**BID #0910-217**

**Carson City Waterfall Fire Watershed Improvements - Phase 2**  
**Labor Commissioner PWP#CC-2010-350**  
**Public Works Project No. 1.0801**  
**Engineer's Estimate: \$200,000.00**

Addendum No. 1

EXHIBIT "A" - Addendum #1

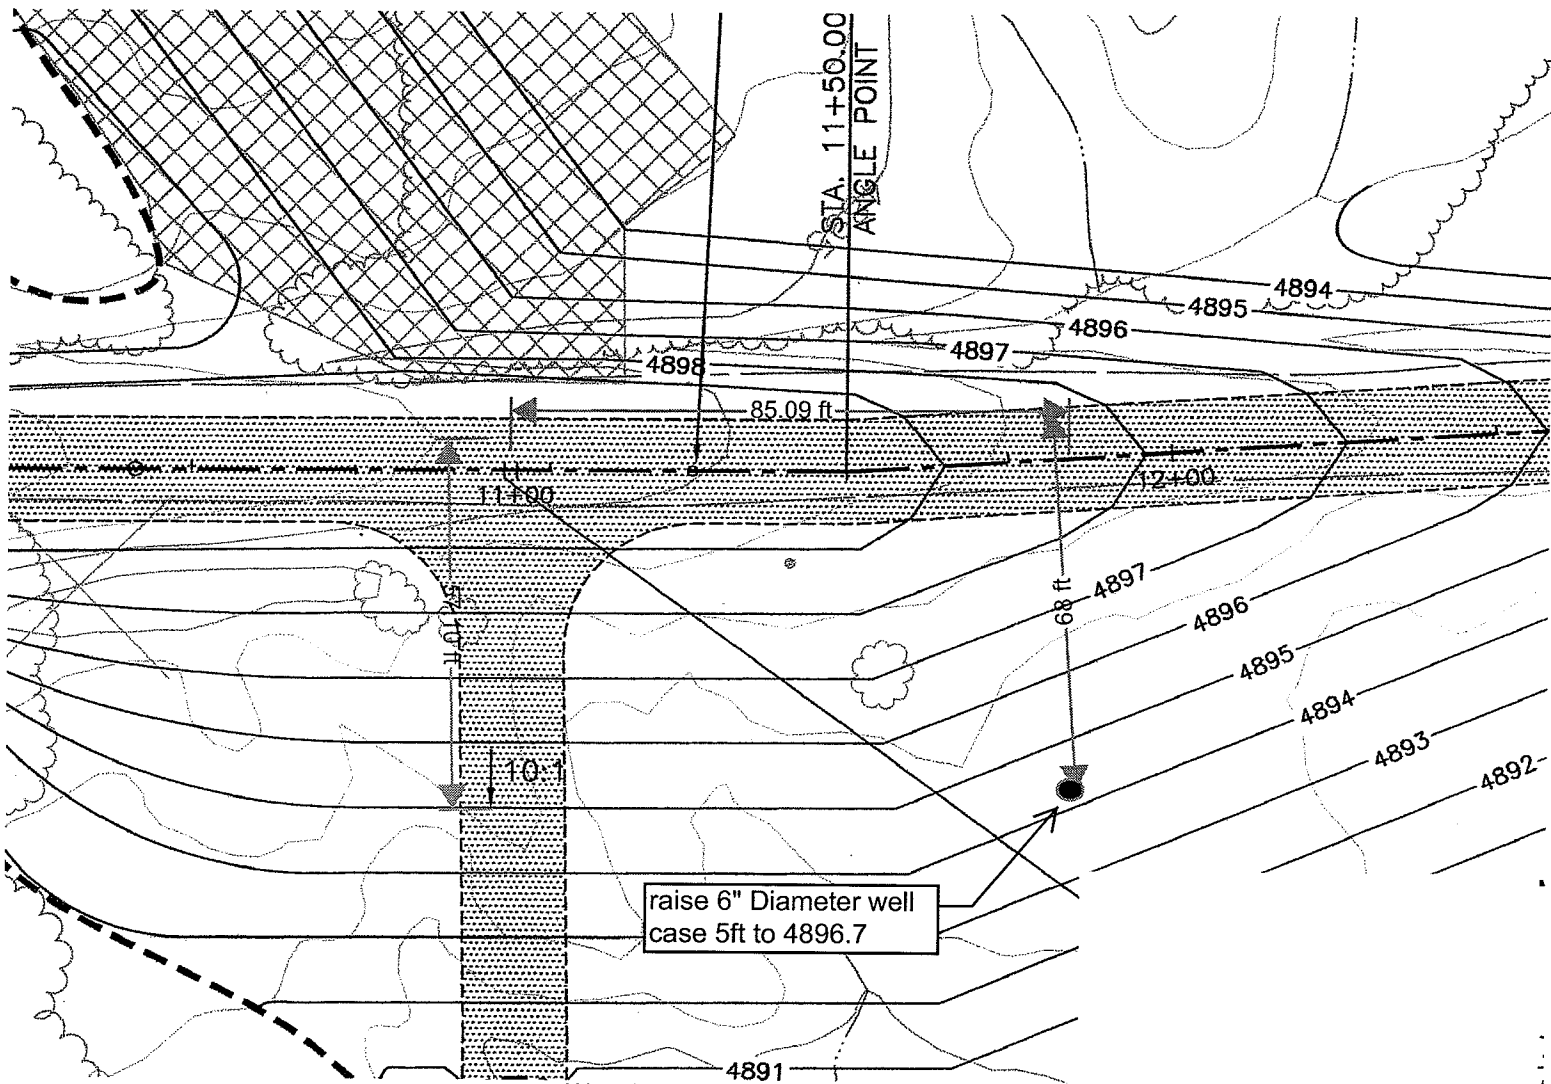
- 1.1 General. Add the following to this section: Two groundwater monitoring wells are in the areas of new work Well no 2 shall be raised approximately 5 feet or as necessary so that the lid is located 24 inches above finished grade, see exhibit "A". The monitoring wells are located along the CCWTP road and are 6 inch steel pipe with steel lids/locks. This work is to be included as a part of the bid item for Earthwork for Basin Excavation and Road Embankment Fill (BP-4).
